Technical Service Information

CHRYSLER A500/518

PREMATURE WEARING OF THE LOW/REV BAND

Figure 1

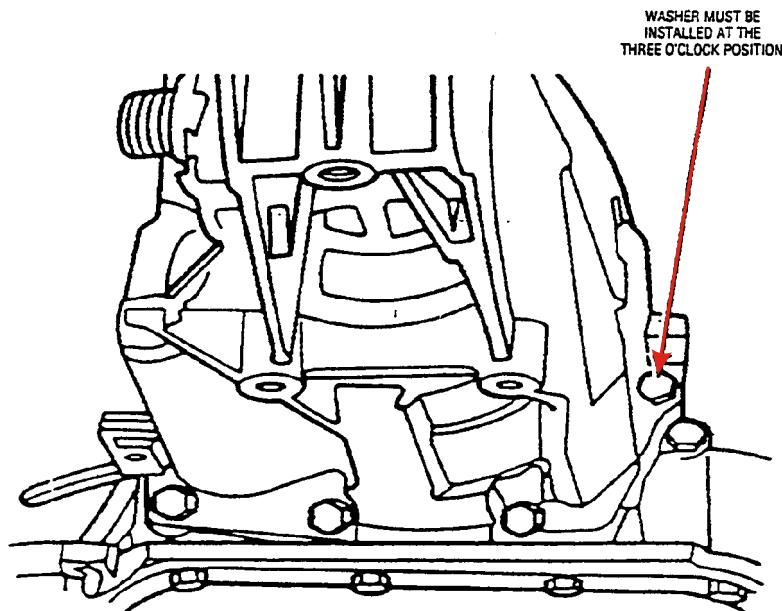
COMPLAINT: Some A-518 transmissions may experience premature wearing of the low/reverse band.

CAUSE: This condition may be the result of one of the overdrive-to-transmission mounting bolt's making light contact with the band strut, resulting in an incomplete release of the band.

CORRECTION: To prevent the possibility of this condition occurring, a washer was installed in production on the overdrive-to-transmission mounting bolt at the **THREE O'CLOCK POSITION** (See Figure 1). The washer entered transmission production in September 1989 beginning with date code 0283.

If a transmission experiences premature wearing of the low/reverse band, or when performing any servicing operation that requires the removal of the overdrive unit from the transmission, be sure the overdrive-mounting bolt in the three o'clock position has a washer installed between the bolt head and the overdrive housing.

If there was no washer on the bolt at the three o'clock position, install a 3/8 inch zinc-coated lock washer such as PN J0120382.
